SERVICE BULLETIN

SB1246

ADDRESSEES	: Owners and operators of coaches listed under 'Application'
VEHICLE MODEL	: C2045, T2140, T2145
SYSTEM/SUBSYSTEM	: Electrical system
BULLETIN TYPE	: Safety Recall NHTSA 12V-495/ TC 2012-344
DATE	: November 12, 2012
SUBJECT	: Alternators mounted on Detroit Diesel engine – To add ground cables
TERMS & CONDITIONS	: Refer to the warranty section further in this Bulletin.

Figure 1: Alternator ground cables

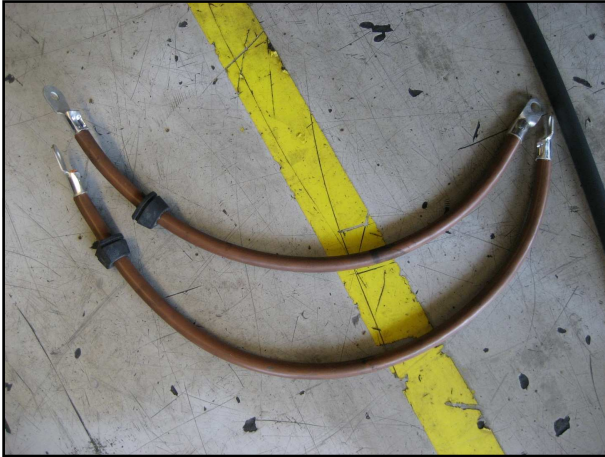
1. Van Hool NV has decided that a defect which relates to motor vehicle safety exists in the above-mentioned coaches, equipped with a Detroit Diesel DD13 engine without ground cables installed on the Prestolite AC172 alternators.
2. The alternator might fail due to excessive heat caused by a progression of the inter-surface corrosion of the electric path of the minus diode plates. The alternator components may melt, possible resulting in smoke and creating a risk for a potential fire hazard.
3. The remedy is to fit a ground cable to both alternators mounted on the engine. For this purpose, ground cables have been made available. Refer to the procedure in this Service bulletin for fitting instructions. The terms and conditions of the campaign have been detailed in the warranty section.

VH reference	Description	Qty.
11271513	Set of two ground cables (with grommets)	1
660224301	Screw	1
660627920	Washer	1

Figure 6

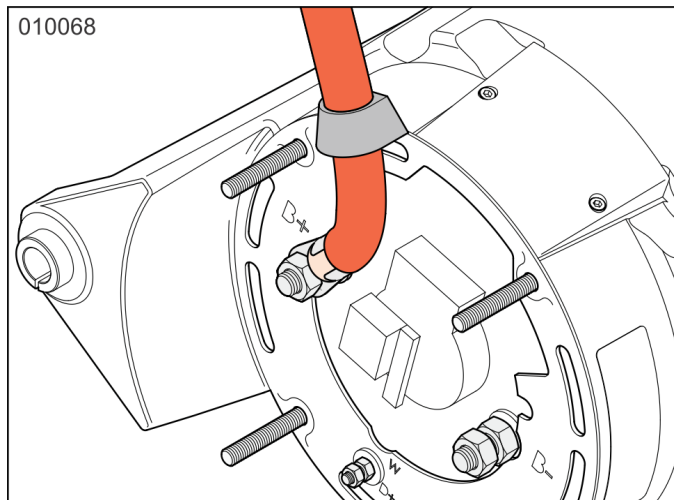
- 9) Slacken the terminal nut of the red positive cables. Re-route the positive cables so that they will pass afterwards through the left hole of the protective cover. Re-tighten the terminal nut of the positive cables to a torque of 6.6 to 9.6 ft.lbf (9 to 13 Nm) (Figure 6 shows upper alternator).

Figure 7

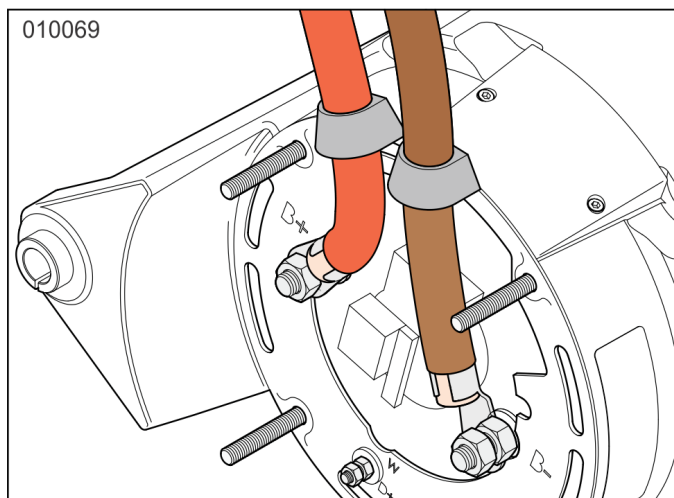
- 10) Install the ground cables on both alternators. Route the ground cables so that they will pass afterwards through the right hole of the protective cover. Re-tighten the terminal nut of the ground cables to a torque of 6.6 to 9.6 ft.lbf (9 to 13 Nm) (Figure 7 shows upper alternator).

Figure 8

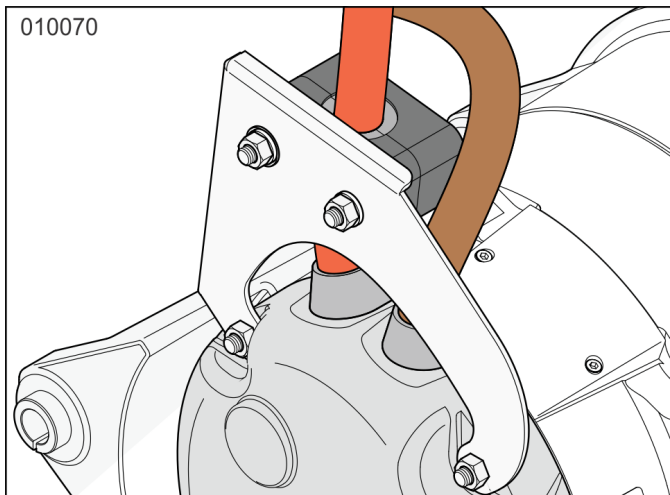
- 12) Install the protective cover of the upper alternator. Verify that the rubber grommets for the cables are in place. Install the positive cable support in reverse of original position and secure the cable clamp to the support. Secure the protective cover (Figure 8).

Figure 9

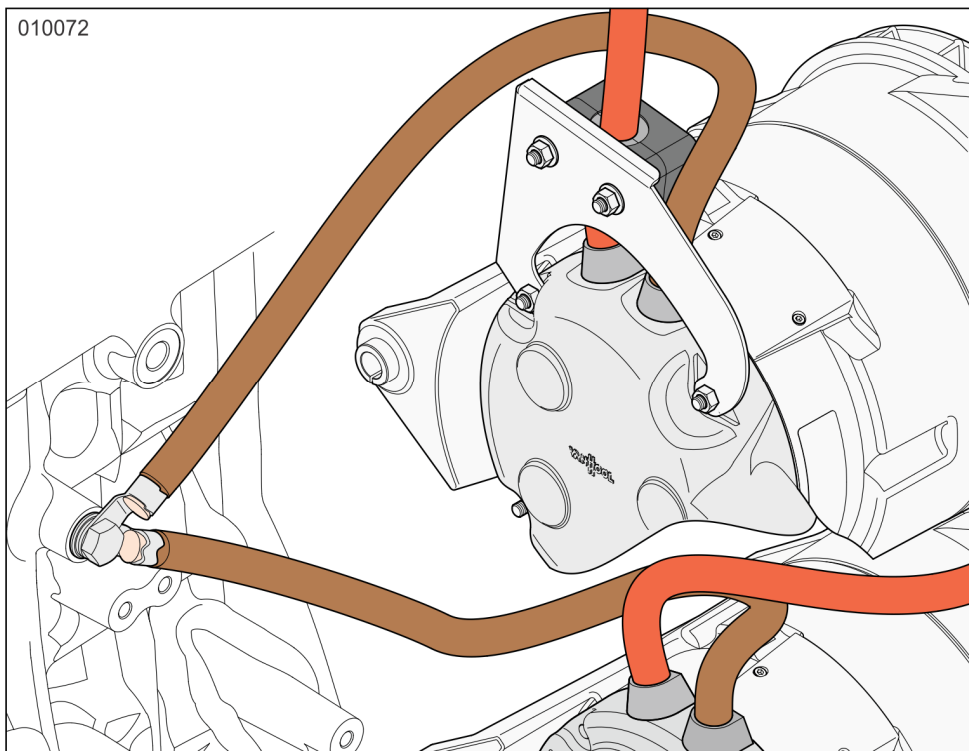
- 13) Reconnect the air hose at the rear of both alternators.
- 14) Secure the ground cable of both alternators to the engine block. Tightening torque of screw: 16 ft.lbf (21 Nm) (Figure 9).
